RE: 4605 Albany NE
Grading Plan
Stamp Date: 10/17/17
Hydrology File: B12D014

RE: 4605 Albany NE
Grading Plan
Stamp Date: 9/27/17
Hydrology File: B12D014

Based upon the information provided in your submittal received 09/27/2017, the Grading Plan **is not** approved for Building Permit and Grading Permit. The following comments need to be addressed for approval of the above referenced project:

ENGINEER'S SEAL  10/17/17 9/27/17 DAVID SOULE P.E. #14522	4605 ALBANY COURT N.W.	DRAWN BY WCWJ
		DATE 9-26-17
	GRADING AND DRAINAGE PLAN	21803-LAYOUT-9-26-17
 Rio Grande Engineering 1606 CENTRAL AVENUE SE SUITE 201 ALBUQUERQUE, NM 87106 (505) 872-0999	SHEET # ---	
	JOB # 21803

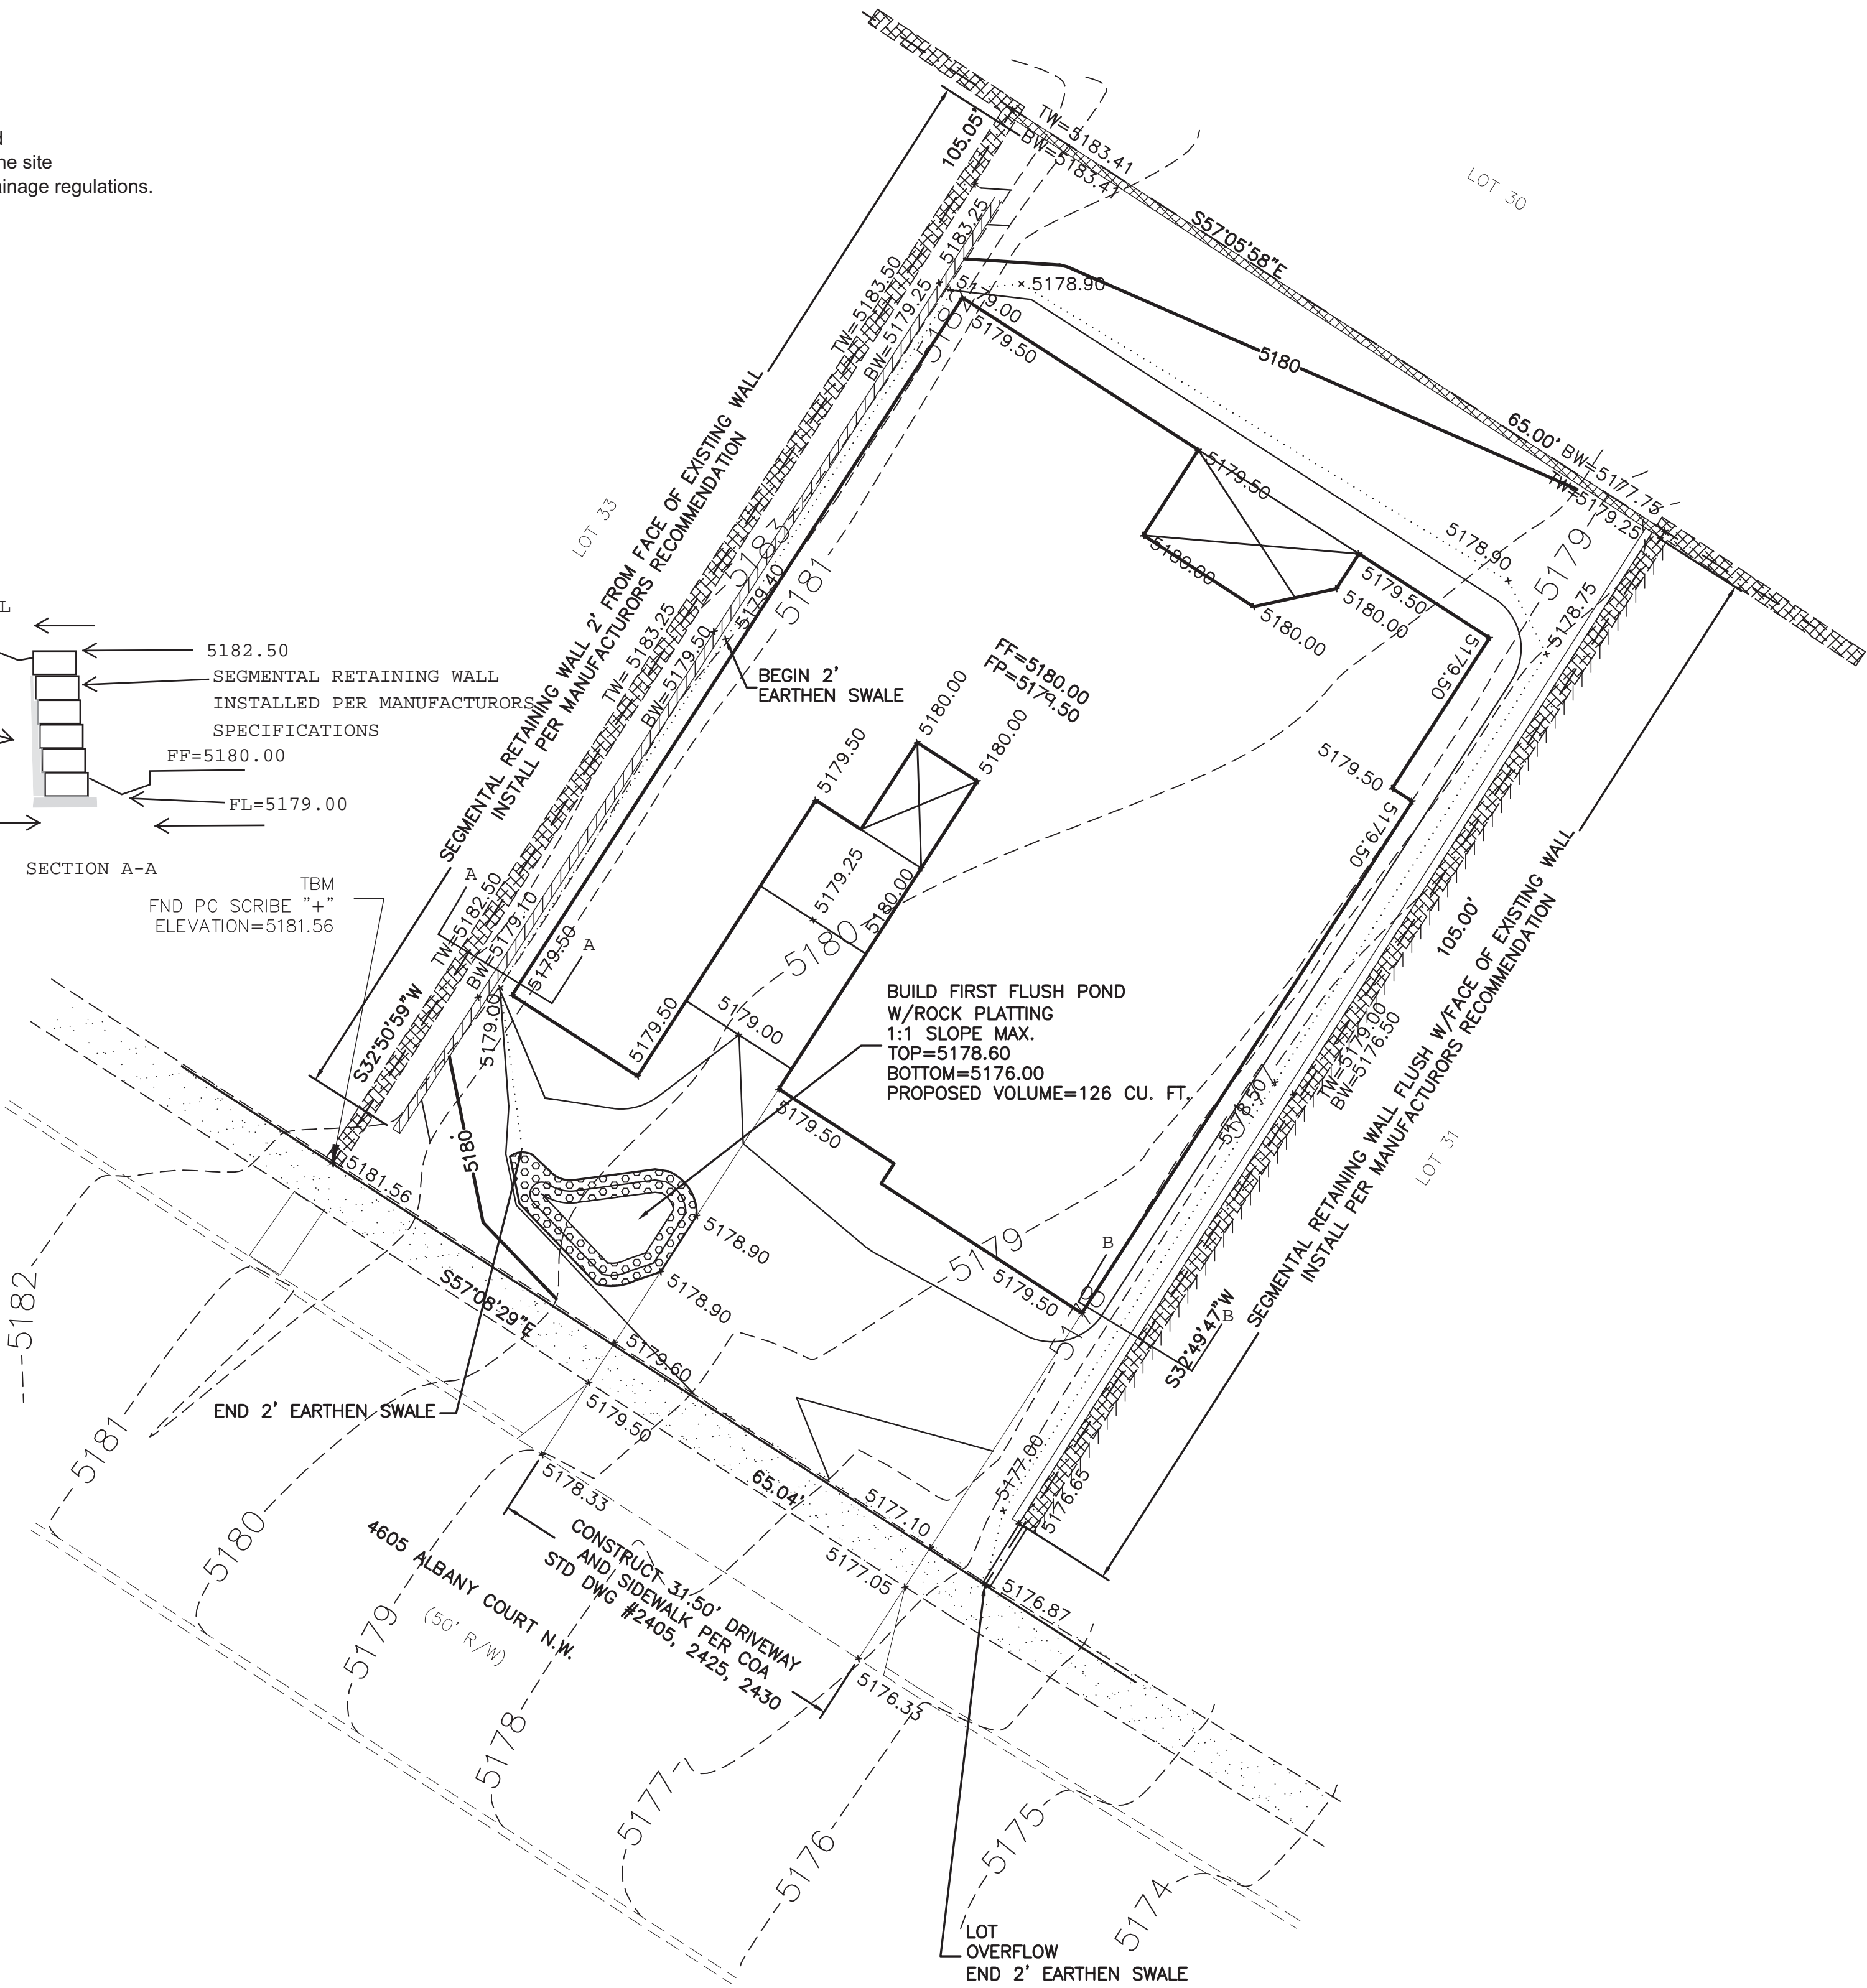
1. Please provide a cross section for both proposed retaining walls. Please include the existing retaining wall, the property line, and footer information. I'm epically concerned about the East wall since you are putting this flush with the existing wall. I want to ensure the integrity of the existing retaining walls. See Attached sheet for the location of the cross sections in question.
